PLANNING REPORT - Major Site and Building Plan Review and CUP

RE: Sunfish Lake – 240 Salem Church Road – Site and Building Plan
Review and Conditional Use Permit

Re: *Site and Building Plan (4th) Review
240 Salem Church Road
City of Sunfish Lake, MN
WSB Project No. 2182-040*

1. GRADING, DRAINAGE AND EROSION CONTROL PLAN
1"=30'

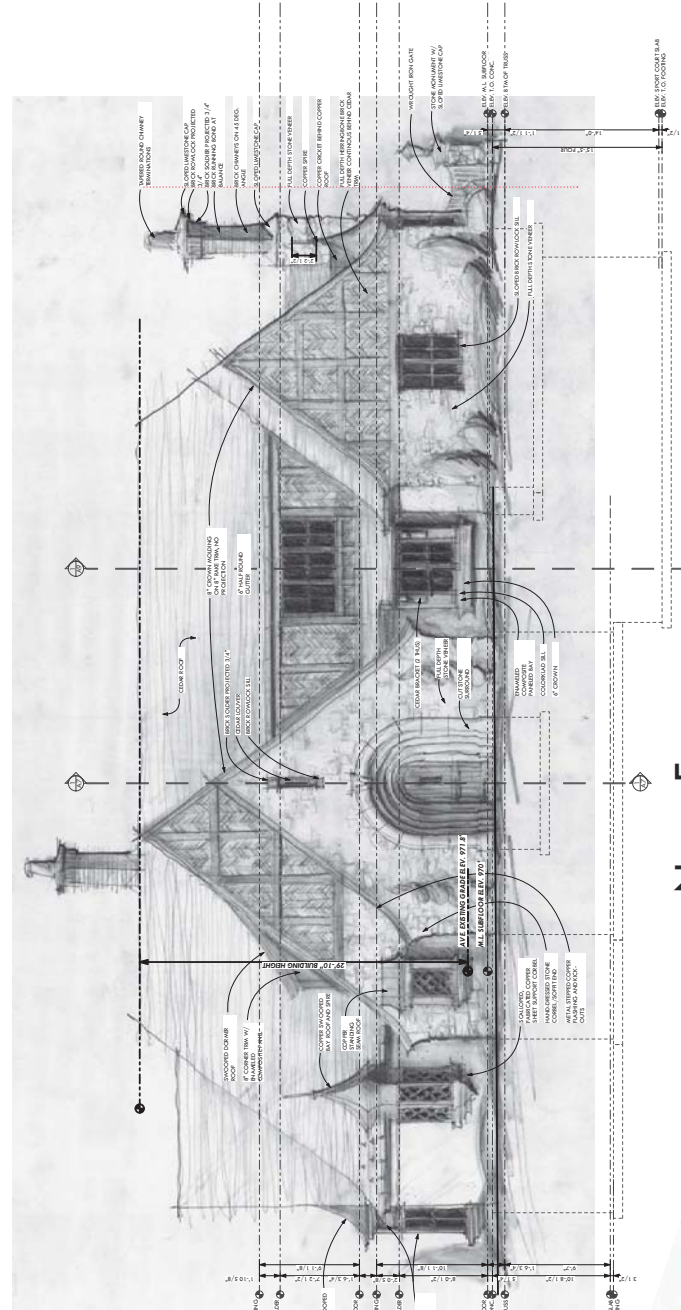
- The top and bottom elevation of retaining wall on the west side of the entrance to the lower level of the east garage should be shown on the plans. It appears that this wall could be 10-feet in height next to the garage. The wall will require a fence for safety. This wall will require to be designed by a registered engineer.

- The driveway slope to lower level of the east garage appears to be approximately 13% from elevation 966 to 970. 10% is the recommended City Standard. The driveway slopes in steep areas such as this should be added to the grading plan.

- The volume control requirements for the site are in conformance with the City policies.
- The grading plan emergency overflow (969.3) on the northwest corner of the driveway slab is within 0.2' of the building openings. The overflow on the north side of the west garage does not provide a minimum of 1-foot of freeboard to the low building opening. The grading plan emergency overflow should be a minimum of 1.5-feet below the low building opening. The driveway slope away from the structure entrance appears to be less than a 2% cross slope to trench drain #1. The developer's engineer should review the grades to provide proper drainage away from the structure and garages to the trench drain (Sheet C300).

- The east garage low building opening does not have adequate freeboard to the building opening. The trench drain #3 emergency overflow does not provide freeboard that is in conformance with the City policies (Sheet C300).

1 Site Plan/Building Height

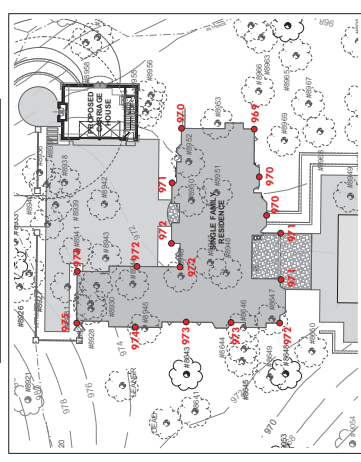
Building Height. According to the Ordinance, no building structure shall exceed two and a half stories or 30 feet in height above existing grade (measured from the average existing ground level). The average existing ground elevation around the proposed home is 971.8 feet in elevation, so that any new structure should not exceed 1001.80 feet in elevation. The home has two stories above average existing grade, and the top of the principal building is 1001.63 feet in elevation (29 ft. 10 in.), meeting the R-1 District height requirement.

5 Site Plan/Building Height
SHEET 7-27

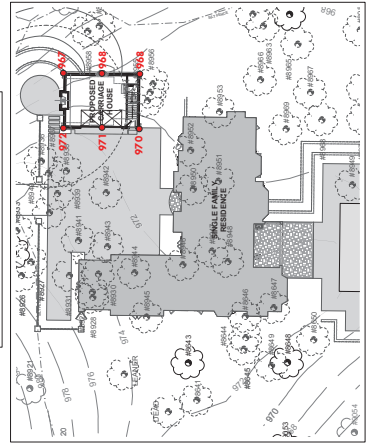
Detached accessory structures in the R-1 District are limited to one story or 16 feet in height. The average grade around the carriage house is 969.3 feet in elevation, in which case the top of roof should not exceed 985.30 feet in elevation. The top of the two story carriage house is 999 feet in elevation, or 29 ft. 6 in. above average grade. This proposal exceeds maximum allowed accessory height by approximately 13 ½ feet. Section 1217.01.C. permits detached accessory structures exceeding one story or 16 feet in height via conditional use permit approval, which the applicants are requesting with this application.
